SUBJECT: AMENDMENT NO. 149 TO FACILITY OPERATING LICENSE NO. NPF-3
(TAC NO. 69569)

DAVIS-BESSE NUCLEAR POWER STATION, UNIT NO. 1

AMENDMENT TO FACILITY OPERATING LICENSE

SAFETY EVALUATION BY THE OFFICE OF NUCLEAR REACTOR REGULATION
RELATED TO AMENDMENT NO. 149 TO FACILITY OPERATING LICENSE NO. NPF-3

Figure 2.1-1 Reactor Core Safety Limit

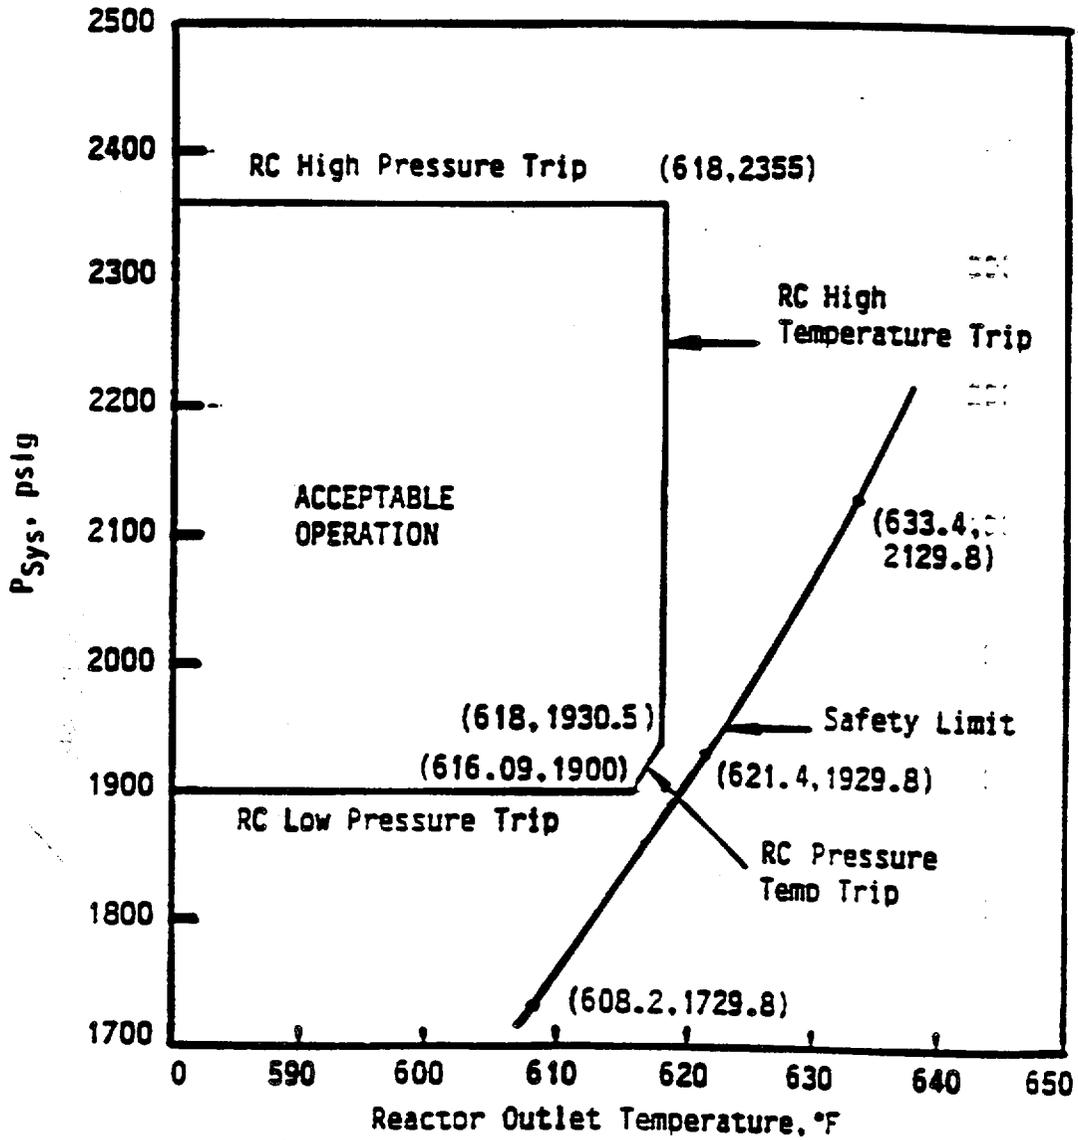
The curve presented in Figure 2.1-1 represents the conditions at which a minimum DNBR equal to or greater than the correlation limit is predicted for the maximum possible thermal power 112% when the reactor coolant flow is 380,000 GPM, which is approximately 108% of design flow rate for four operating reactor coolant pumps. (The minimum required measured flow is 389,500 GPM). This curve is based on the following hot channel factors with potential fuel densification and fuel rod bowing effects:

The curve of Figure 2.1-1 is the most restrictive of all possible reactor coolant pump-maximum thermal power combinations shown in BASES Figure 2.1. The curves of BASES Figure 2.1 represent the conditions at which a minimum DNBR equal to the DNBR limit is predicted at the maximum possible thermal power for the number of reactor coolant pumps in operation or the local quality at the point of minimum DNBR is equal to the corresponding DNB correlation quality limit (+22% (B&W-2) or +26% (BWC)), whichever condition is more restrictive.
